NEW HIGH SCHOOL IN BUNGENDORE - APPLICATION NO. SSD-14394209

Objection from Save Bungendore Park Inc.

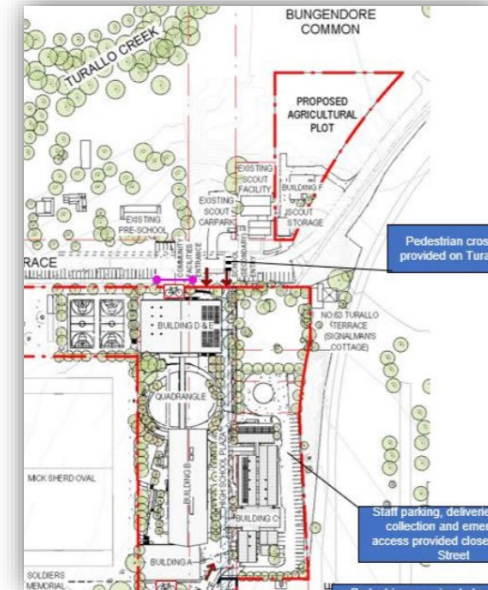
132.	7.4.5 – Parking	<p>The proposed development fails to address the SEARs requirements and fails to allow sufficient parking. It does not address the adequacy of car and motorcycle parking and bicycle parking provisions when assessed against the relevant car / bicycle parking codes and standards. Further, the EIS notes that the proposal will:</p> <ul style="list-style-type: none"> • result in the loss of 60 parking spaces, with 40 new spaces to be built on Turallo Terrace (reducing the Park, the amenity of residents and the safety of the preschool); and • provide staff parking in the Palerang Council Building carpark sufficient for the initial expected staff requirements. <p>The EIS fails to address:</p>

<ul style="list-style-type: none"> the safety impact, and the impact on Bungendore Preschool and residents of Turallo Terrace of significant parking being constructed on that street; parking for Bungendore Post Office; parking for Bungendore School of Art; parking for staff and visitors to the proposed community library, “health hub” or Council kiosk; parking for parents, staff and visitors to Bungendore Public School (who rely on the Gibraltar St parking); parking for parents and visitors to the proposed high school; parking for any increased staff numbers required to accommodate any future growth; the critical shortage identified in the recent Council report referred to at item 36 above; parking for visitors to Bungendore Preschool and the Bungendore Scout Hall (which is rumoured to be used for play group and day care following the demolition of Bungendore Community Centre), given that the proposed current Scout Hall parking is proposed to be allocated to Abbeyfield Australia to replace their site which is now planned to form part of the proposed development; and parking for students driving to school. The plan does include any dedicated student parking. The EIS notes (Table 7-2) that 23 students will drive to school. This is based on initial estimates of “up to” 450 students, which will be rapidly exceeded. The Applicant has not supported this estimate and it is likely to be a significant underestimate, given that the Applicant has failed to appreciate the rural nature of the location in all aspects of planning. <p>Children in rural areas typically learn to drive as soon as they are allowed; given the long distances, limited availability of bus transport and unsafe cycling conditions for students travelling surrounding rural areas, many Year 11 and 12 students will drive themselves.</p> <p>Of a school population of 450, 150 may be in Year 11 or 12. If only one quarter drive to school, almost 40 parking spaces will be required. This rises to almost 50 in 2036 based on the Applicant’s estimate of 566 pupils. The demand is even greater if (as is suggested at para 24 above) the Applicant’s estimates fail to consider anticipated growth. There is no provision for this.</p>

**Location of
proposed
development**

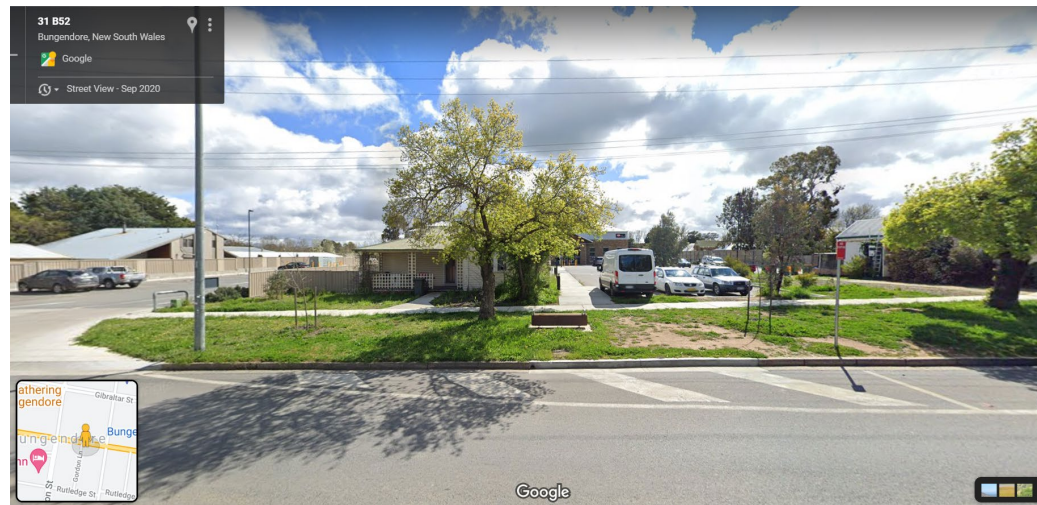
162.	Appendix 4 - 1.6 – Bulk and Scale	<p>The GANSW recognised that the proposed development was inappropriate in bulk and scale for the town. The Applicant fails to address this. Instead, the Applicant states that the proposed development is “generally isolated from the town and neighbouring buildings”.</p> <p>This is absurd and inconsistent. The Applicant has made frequent public statements (including in the EIS and p33 of Appendix 4) highlighting the central location of the development. Indeed, in 5.1 (page 13) of Appendix 4, the Applicant notes that “the site is in a relatively central location to the town area and located on the eastern edge of the historic portion of the town.” Similarly, in 7.3.3 of the EIS, the Applicant states that “the site is situated in a relatively central location of Bungendore” with the surrounding area “generally characterised by low density residential uses, civic and public buildings, and recreational open space.” It is in fact in the absolute geographic centre of Bungendore, as shown below.</p> <p>The development will dominate the approach to the centre of Bungendore along McCusker Drive (a major thoroughfare from the Elmslea subdivision), where it will be directly in front of pedestrians and motorists who will approach from below, on a rising, right-hand bend.</p> <p>The scale is such that it is likely to dominate the view to Bungendore approaching the town from the east on the Kings Highway.</p>

The Applicant has chosen to use misleading perspectives of the Bungendore IGA Supermarket and Bungendore Scout Hall to suggest that the proposed development is consistent with the town's character. This is incorrect. In particular:
